Agenda
Lane Cove Local Planning Panel Meeting
21 January 2025

Item No: LPP1/25
Subject: S4.55 - 235 Burns Bay Road, Lane Cove West
Record No: DA21/161-01 - 76945/24
Division: Planning and Sustainability Division
Author(s): Sam Wilson

Description of the proposal to appear on determination	Section 4.55 modification application of a mixed-use shop-top housing development including minor internal and external amendments.
Zone	E1 Local Centre
Is the proposal permissible within the zone	Yes

The section 4.55 application seeks approval for the following modifications to the originally consented development at 235 Burns Bay Road, Lane Cove West;

Figure 5: Basement (Source: Architect)

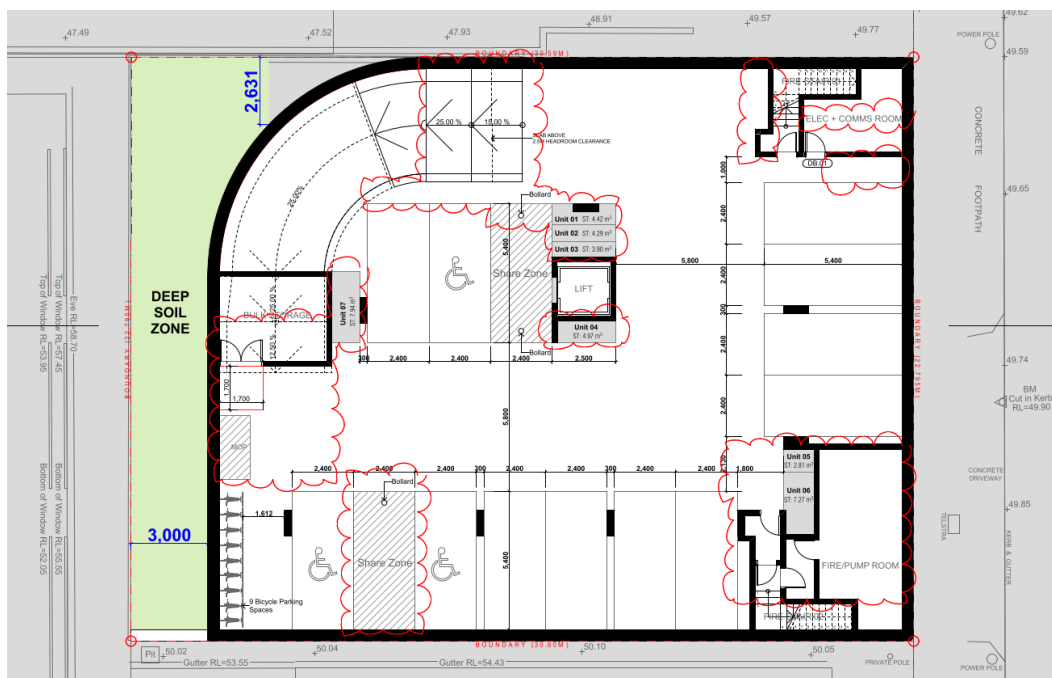
Basement:

- Amendment of the ramp slope;
- Relocation of U01, U02, U03, U04, U05, U06, and U07 storage spaces;
- Enlargement of the fire/pump room;
- Relocation of the bulky waste storage room;
- Relocation of the electrical communications room; and
- Relocation of the shared zone and disabled parking

Figure 6: Ground Floor (Source: Plans)

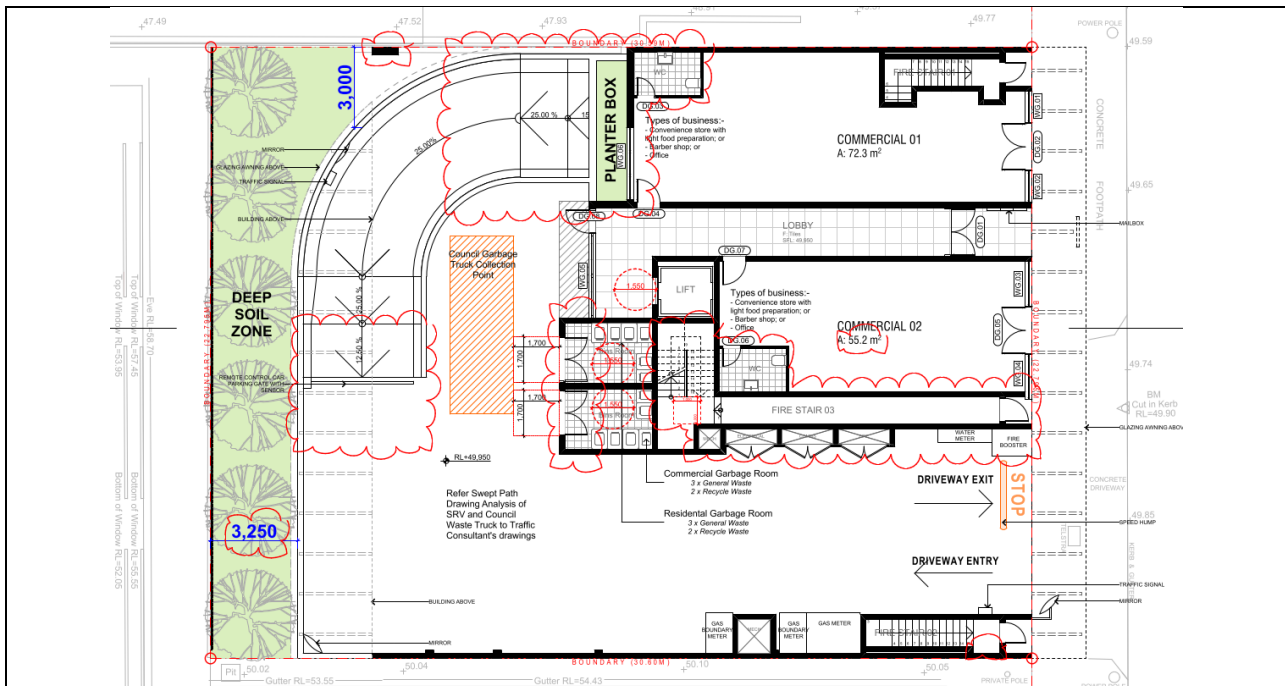
Ground Floor:

- Increase of the rear setback to 3.25m;
- Amendment of the ramp slope;
- Enlargement of garbage rooms;
- Reduction in planter box size;
- Reduction in Commercial Space 02 size to 55.2m²; and
- Modification of fire stairs and service zone.

Figure 7: First Floor (Source: Architect)

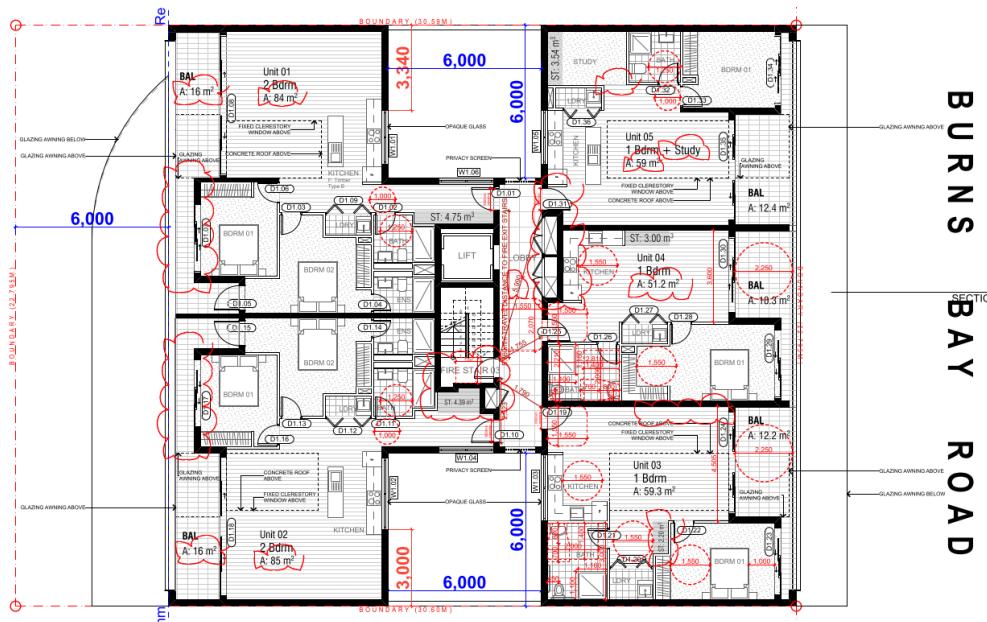
First Floor:

- Unit 01: Reduction in balcony area;
- Unit 02: Reduction in balcony space and storage location;
- Unit 04: Reduction in internal floor area; and
- Unit 05: Removal of wall nigg at study room and relocation of entry door.

Figure 8: Second Floor (Source: Architect)

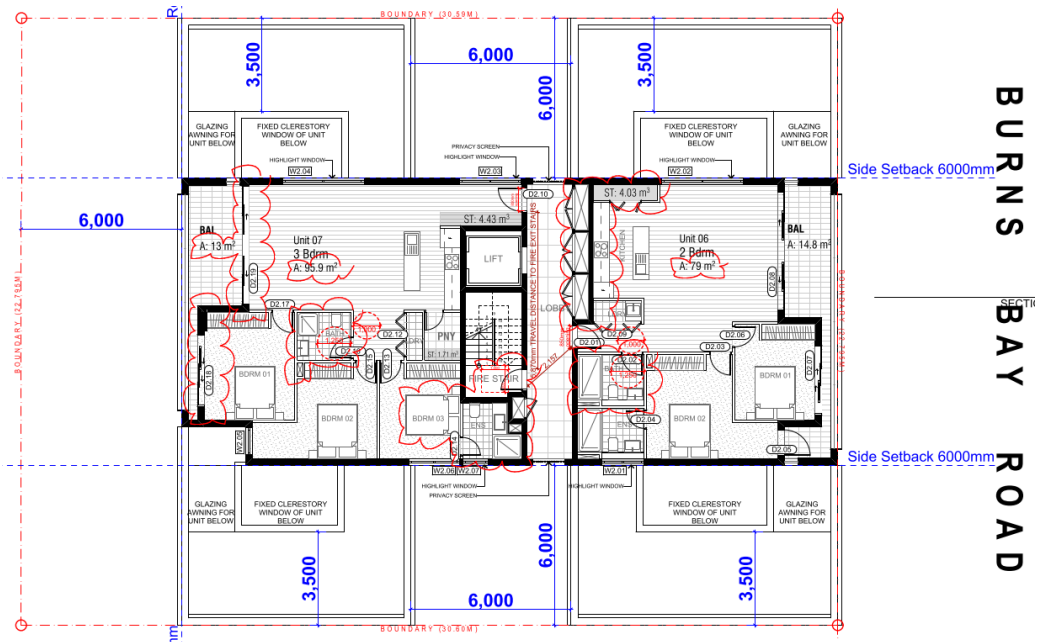
Second Floor:

- Unit 06: Reduction of floor area due to proposal of risers;
- Unit 06: Storage space with walls and bi-fold door opening;
- Unit 06: Adjust layout of bathroom;
- Unit 07: Adjust balcony space (POS) and bathroom layout;
- Unit 07: Adjust Bedroom 03 and Ensuite layout; and

- Unit 07: Reduction of floor area.

Figure 9: Roof Floor (Source: Architect)

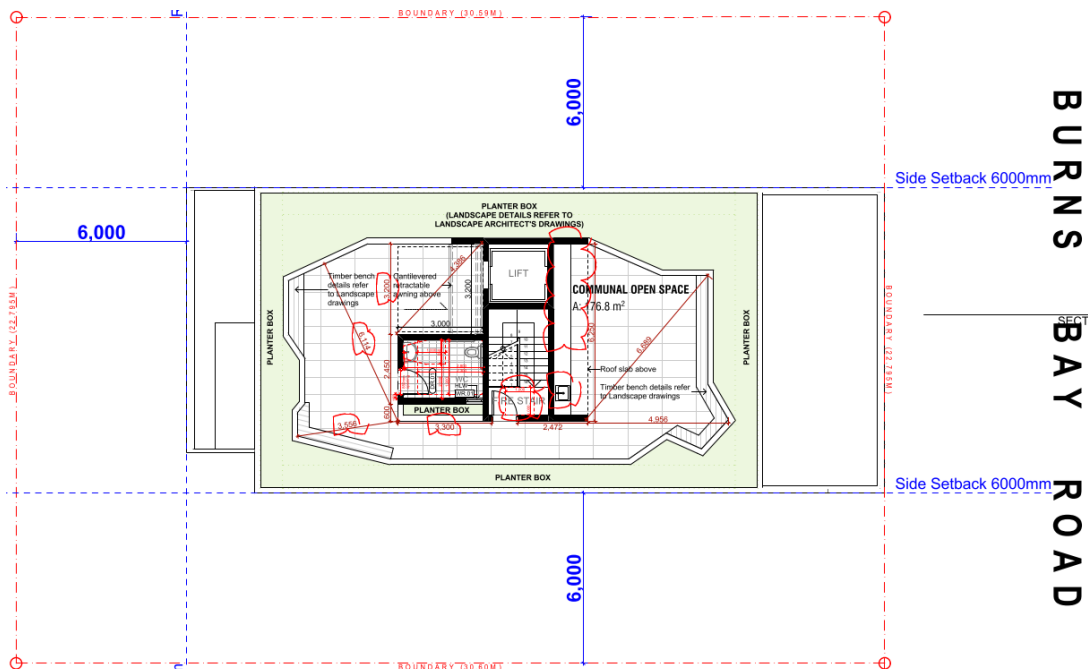
Roof:

- Enlargement of outdoor cooking facilities.
